Historic Architectural Review Commission Staff Report for Item 6c

Application Number: H15-01-1540

Address: #818 Sawyers Lane

Demolition of back portion of house.

1962 Sanborn Map

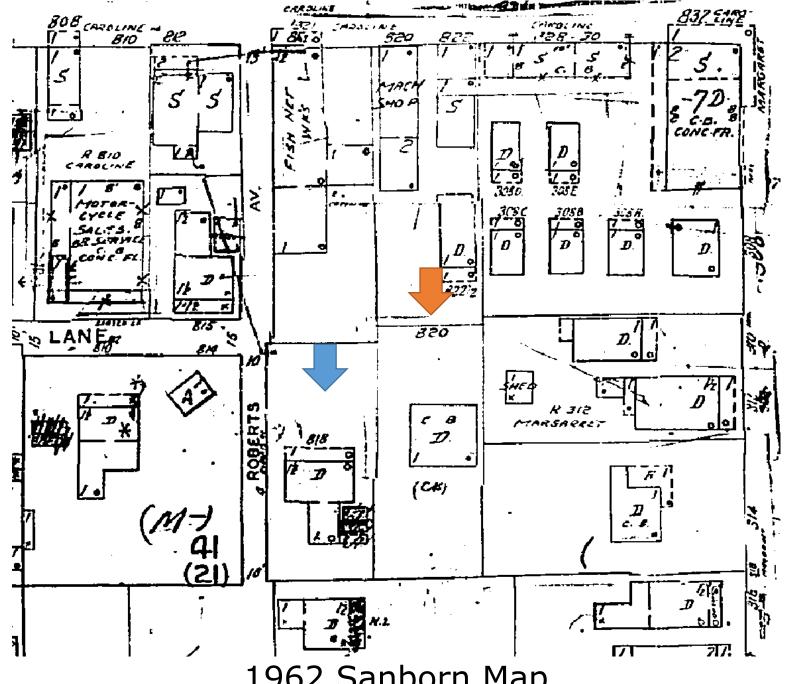
This Certificate of Appropriateness proposes the demolition of a non-historic addition attached the rear of 818 Sawyers Lane. The current addition does not match the one-story addition that appears in the 1962 Sanborn map, and it does not have any character defining features.
